PROJECT NO. : 5917B

ADDENDUM NO.: 2
ISSUED: 4/27/2020

Project: NEW FLOORING AND FLOORING REPLACEMENT AT BROWN COUNTY ELEMENTARY SCHOOL
BROWN COUNTY COMMUNITY UNIT SCHOOL DISTRICT #1
503 NW CROSS STREET
MT. STERLING, IL 62353

ELEMENTARY SCHOOL MAIN LEVEL FINISH PLAN
 SCALE: 1/8" = 1'-0"
 NORTH

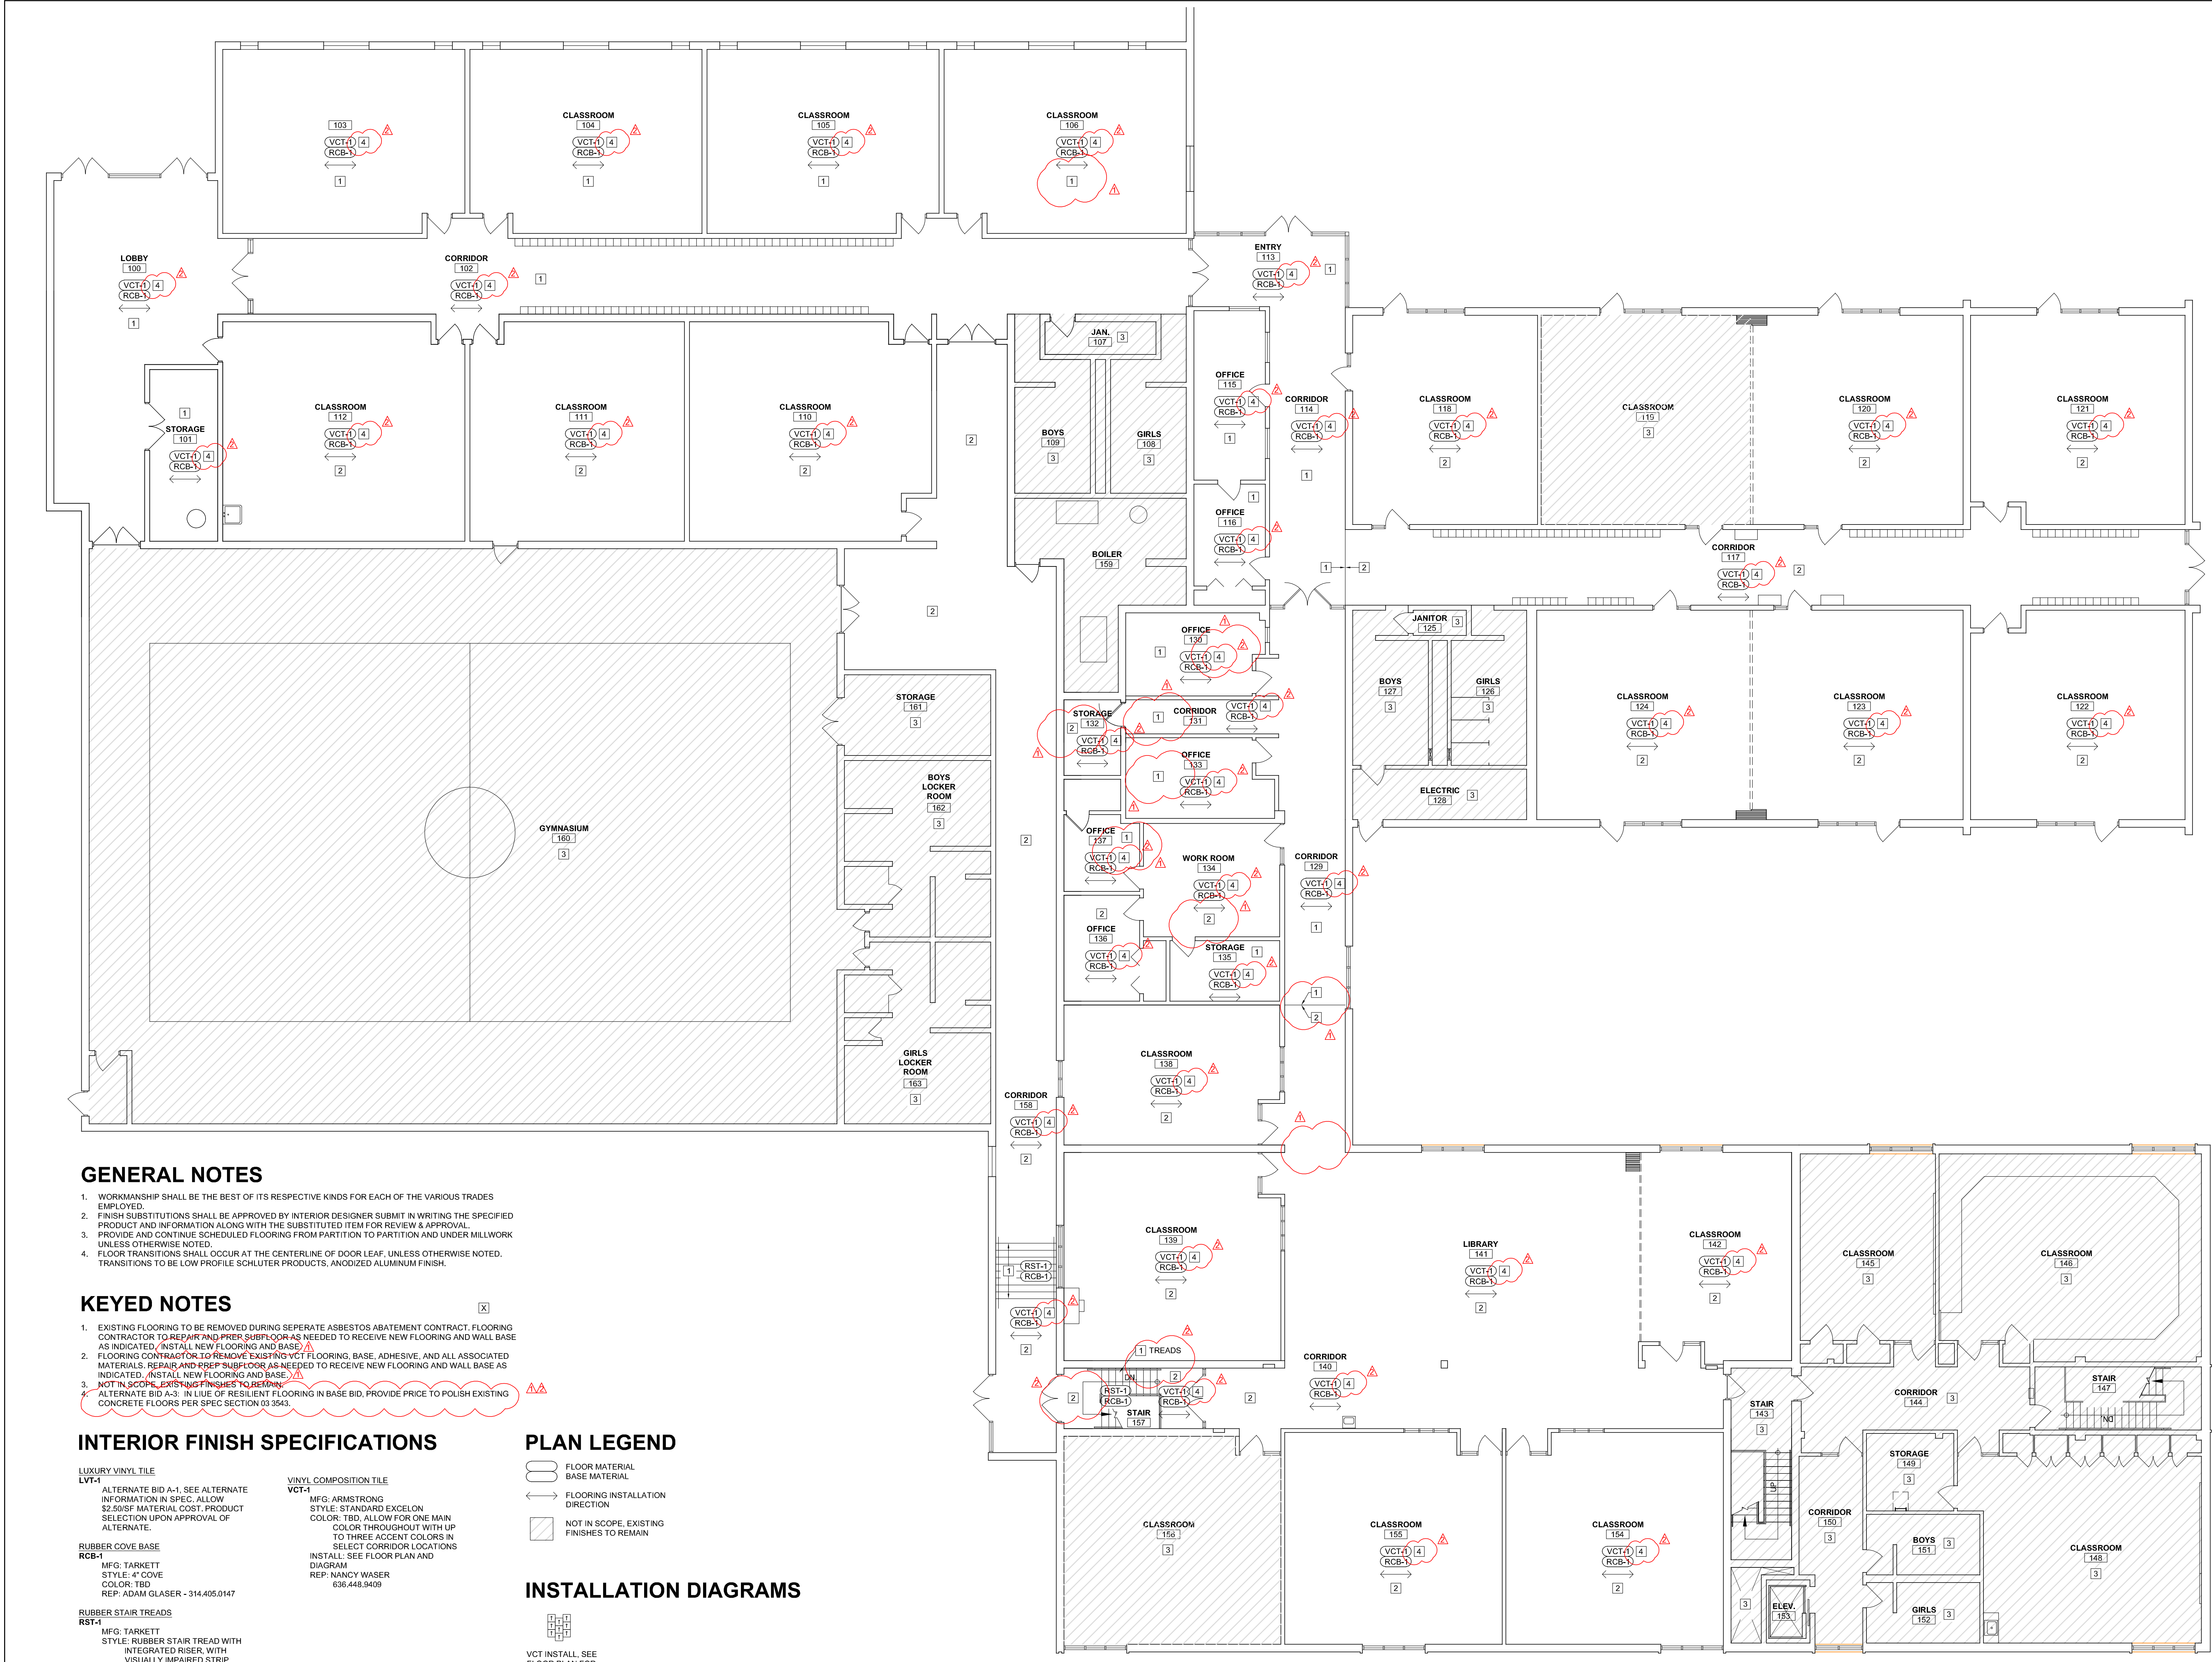
ITEM	DESCRIPTION		
<u>SPECIFICATIONS</u>			
1.0	Section 00 4113 Bid Form	Replace	Replace with attached section. Alternate Bid A-3 added.
2.0	Section 01 2300 Alternates	Replace	Replace with attached section. Alternate Bid A-3 added.
3.0	Section 03 3543 Polished Concrete	Add Section	
<u>DRAWINGS:</u>			
1.0	Sheet I101	Replace	Replace with attached sheet. Alternate Bid A-3 added, other misc edits.

- EXISTING FLOORING TO BE REMOVED DURING SEPERATE ASBESTOS ABATEMENT CONTRACT. FLOORING CONTRACTOR TO REPAIR AND PREP SUBFLOOR AS NEEDED TO RECEIVE NEW FLOORING AND WALL BASE AS INDICATED. INSTALL NEW FLOORING AND BASE.
- FLOORING CONTRACTOR TO REMOVE EXISTING VCT FLOORING, BASE, ADHESIVE, AND ALL ASSOCIATED MATERIALS. REPAIR AND PREP SUBFLOOR AS NEEDED TO RECEIVE NEW FLOORING AND WALL BASE AS INDICATED. INSTALL NEW FLOORING AND BASE.
- NOT IN SCOPE. EXISTING FINISHES TO REMAIN.
- ALTERNATE BID A-3: IN LIEU OF RESILIENT FLOORING IN BASE BID, PROVIDE PRICE TO POLISH EXISTING CONCRETE FLOORS PER SPEC SECTION 03 3543.
